ADDENDUM NO. 1

FINAL ENVIRONMENTAL IMPACT STATEMENT

Everett Riverfront Redevelopment

**ADDENDUM NO. 1 TO THE EVERETT RIVERFRONT REDEVELOPMENT
FINAL ENVIRONMENTAL IMPACT STATEMENT
November 24, 2008**

Figure A1-11

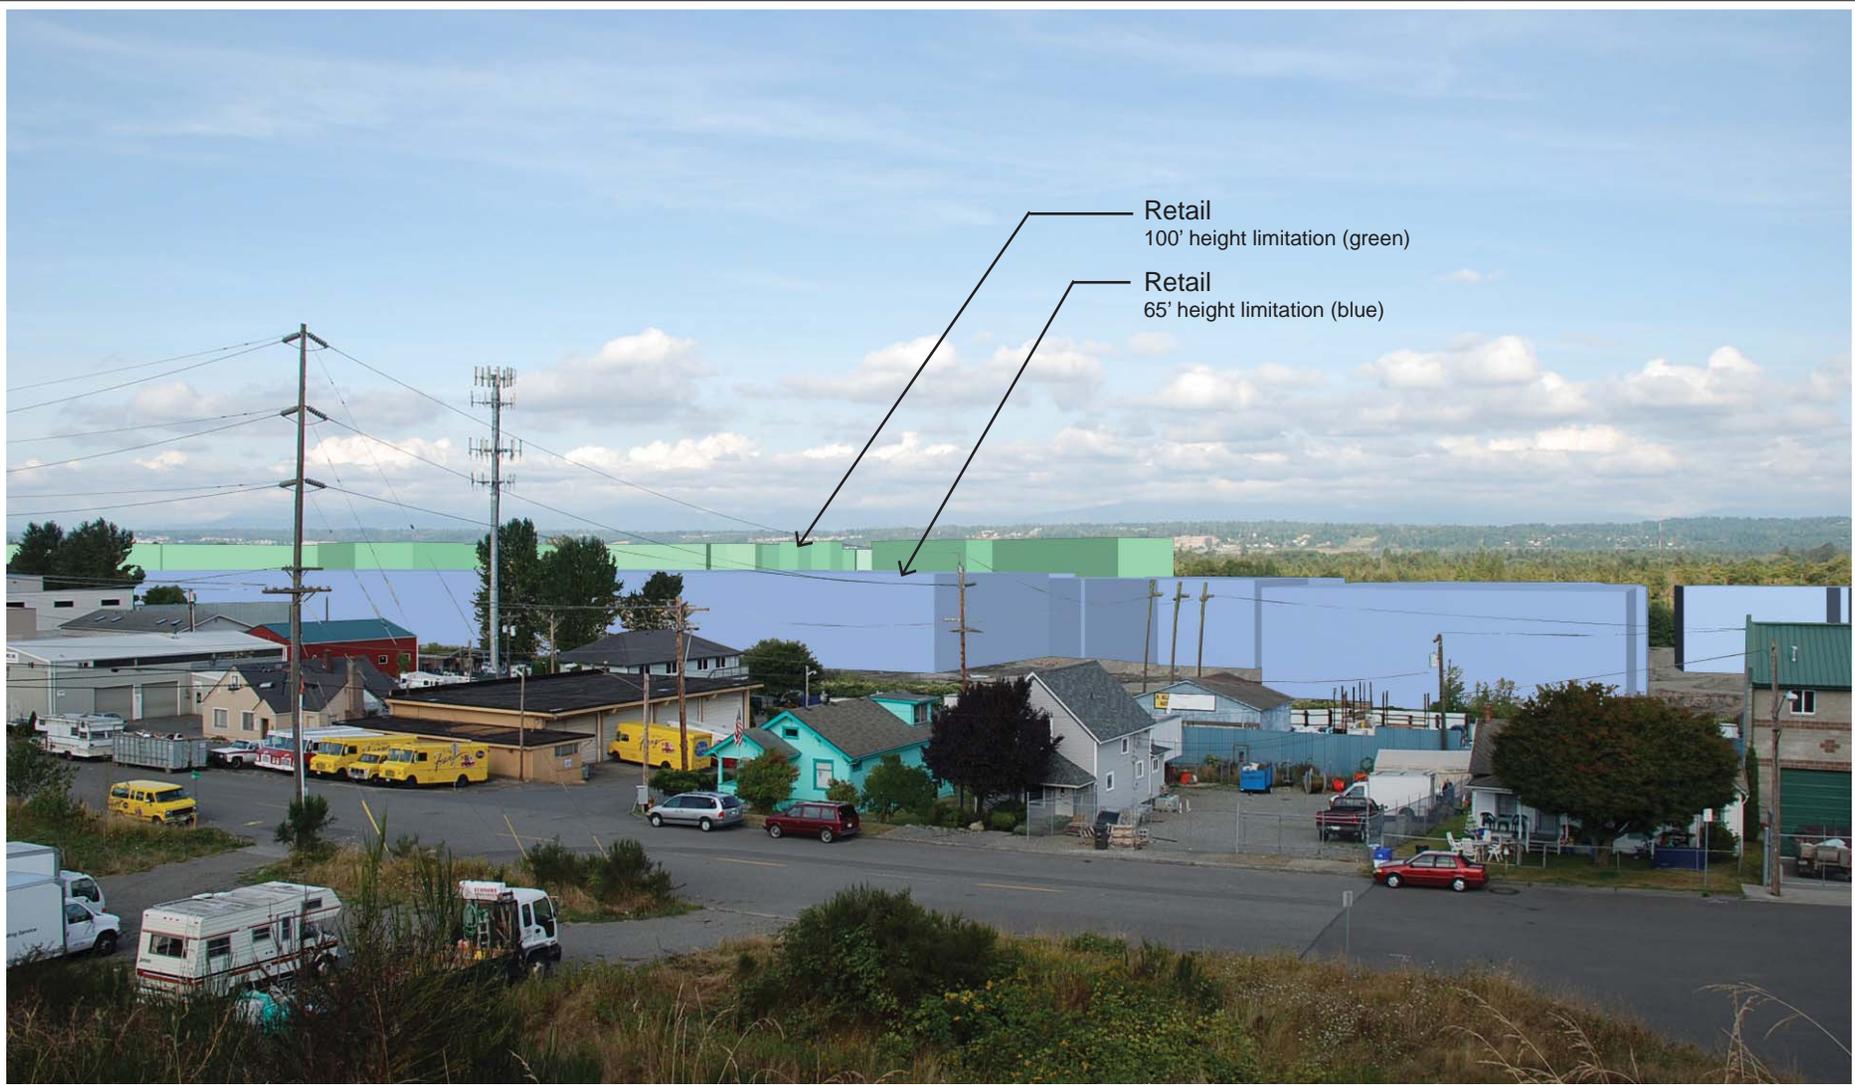
- f) **Viewpoint 6. S. 3rd Ave below and north of the 41st Street Overpass – Looking north northeast.** This location has the broadest view of the proposed development on the Landfill/Tire Fire and Eclipse parcels from any off-site location. The distant mountains provide the most prominent visual resource in this viewpoint. The US-2 Bridge is visible in the extreme northwest corner of the view. (This view was photographed for this Revised View Analysis during pre-load activities on the landfill.) The foreground is a disorderly mix of littered open space, dirt parking lots, and disparate small industrial facilities. This location is not representative of views from any residential areas as it is much lower in the landscape and closer to the development than any such area. The Revised View Analysis (Figure A1-12) shows the development will be prominent in this location. Although the angle of the

photograph in this Revised Analysis is slightly different than the one in the Draft EIS the impact is generally the same. The primary difference from the increased height of buildings on the landfill/tire fire site is the US 2 Bridge is no longer visible in the background. View of the bridge from this location at present is a very minor part of the vista comprising less than 1% of the view. More prominent views of the mountains and portions of the lower hills in the background are still visible. Also, as noted in the introduction to this analysis, the depiction shows 100% of the buildings at 100 feet while the proposal would only allow 60% so the potential impact is proportionately less than shown. A 15 foot appurtenance on these buildings would have no material impact on the result of the analysis. One can make a reasoned estimate of the potential impact by comparison between the two building elevations shown which is between 65 feet and 100 feet. A 15 foot appurtenance would be less than half the height difference between the 65 foot and 100 foot tall buildings shown. When added on top of the buildings shown, the equipment would potentially block a portion of the view of foothills in the background. The Revised View Analysis from Viewpoint 6 demonstrates there is no significant impact from the proposed change in maximum height of 100 feet on a portion of the Landfill/tire fire pad.

Figure A1-15

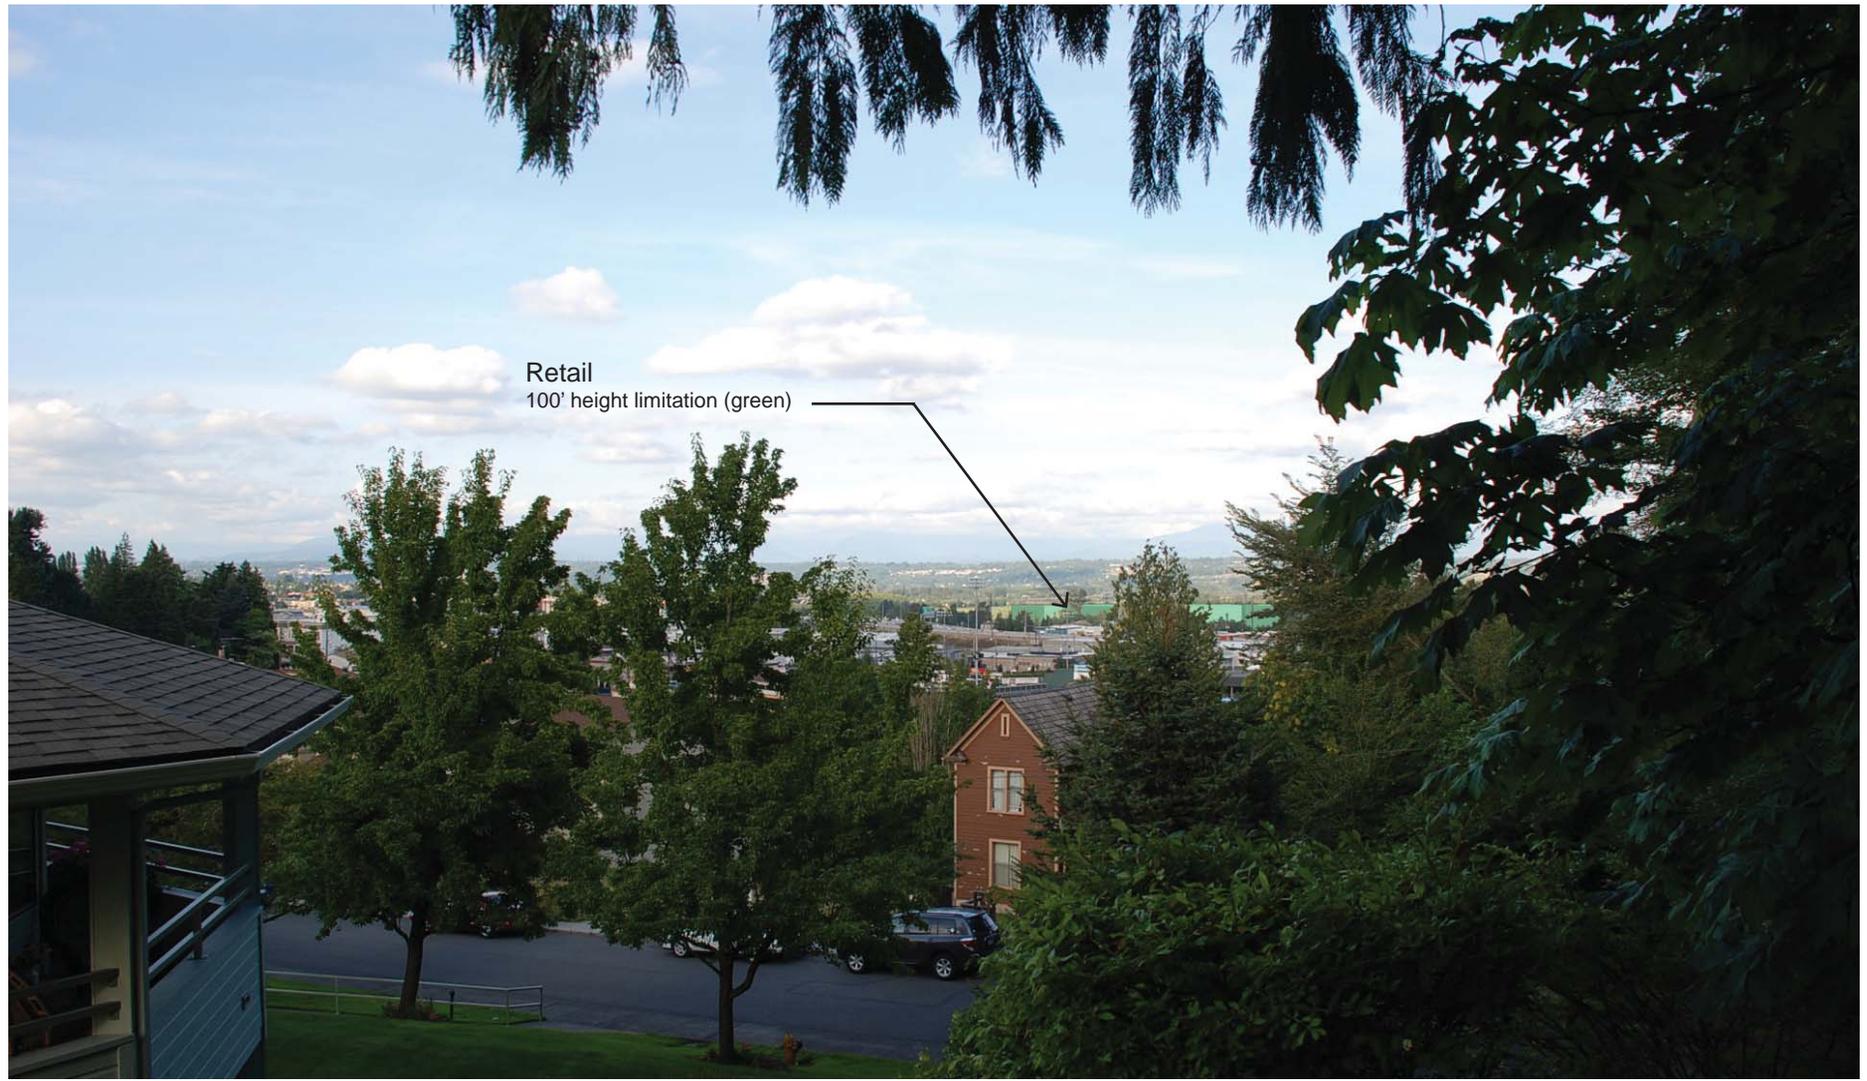
- h) **Viewpoint 8. 1699 40th St. - Looking due East, Northeast, and East-southeast.** The prominent view from the residential community is the distant vista with the Cascade Mountains as the dominant form. The foreground, with a diverse pattern composed of small residences, industrial and commercial buildings, part of the Everett Memorial Stadium complex and a variety of trees, obstructs much of the view of the site. The Revised View Analysis (see Figure A1-16) shows that the development on the landfill will become visible in a small part of the middle of this view. Views of the mountains and foothills are still prominent. (As a note in comparison with the analysis in the Draft EIS there has been dramatic growth in vegetation in and around this location that has altered the view and will likely continue to alter it.) The Revised View Analysis from Viewpoint 8 demonstrates there is no significant impact from the proposed change in maximum height of 100 feet on a portion of the Landfill/tire fire pad.

Figure 6. Potential restoration channels, Wetland C Simpson Lee site and calculated excavation quantities.

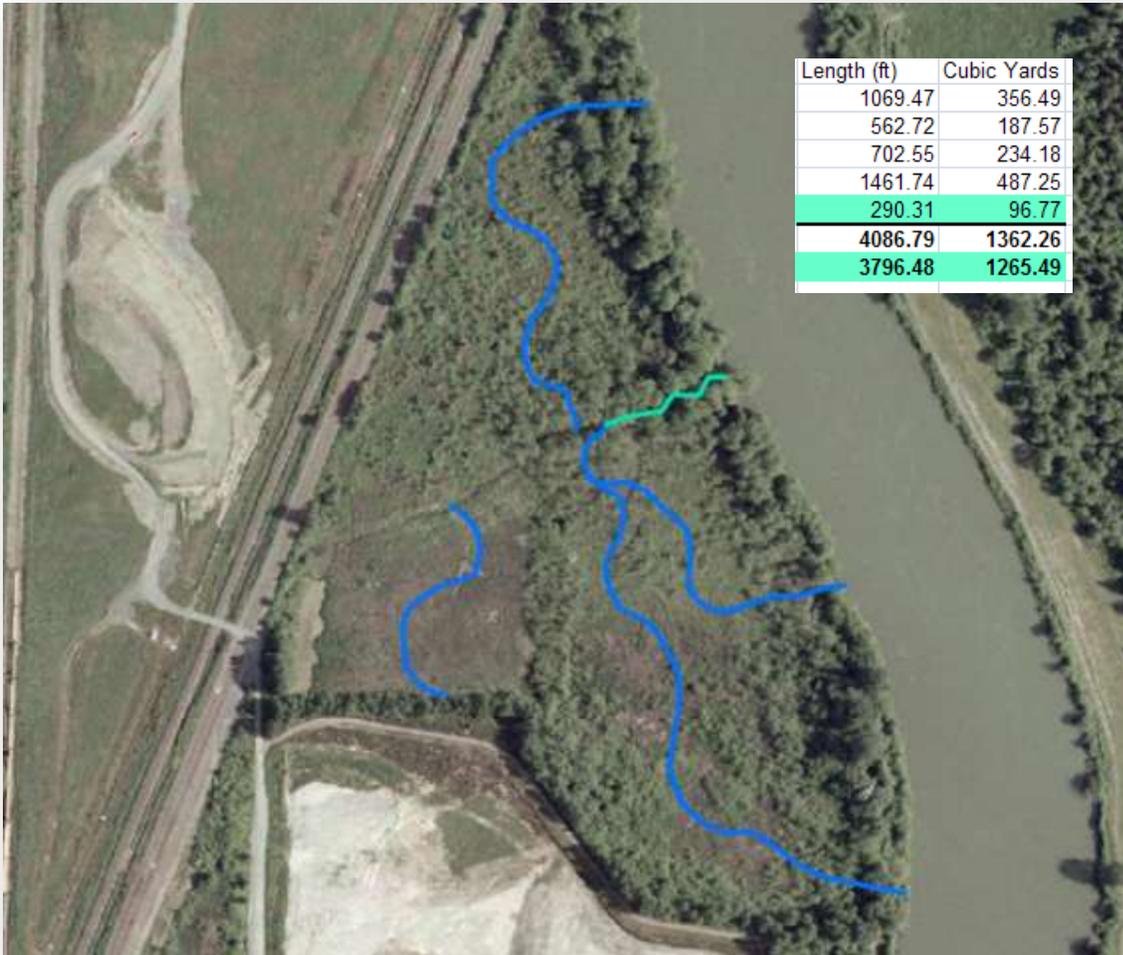
During this site visit, we observed numerous small channels that were flooded within 9” to 14” of the adjacent marsh surface. This would indicate that the marsh soils (clay loam), through capillary action, would be saturated to the surface during a tide that is less than a MHHW tide (9.17 ft NAVD88). Tidal flooding appeared to extend up the main channel to the Powerline Channel (Figures 5 and 2). In discussions with Si Simenstad, distributary channels, and not dendritic, are most commonly found in a marsh of this elevation (personal communication 9/15/08). The volume of dredging needed for small distributary channels (3’ wide by 3’ in depth) was estimated at 1,266 cubic yards based on the conceptual restoration design (Figure 6).

Note: The turquoise reach shown in Figure 6 and shaded rows on the table show the stream length and estimated volume of excavation for this reach. Excavation of this may not be necessary to achieve tidal circulation and the last shaded row in the table shows the stream length and volume of excavation if this reach is not included in the totals.
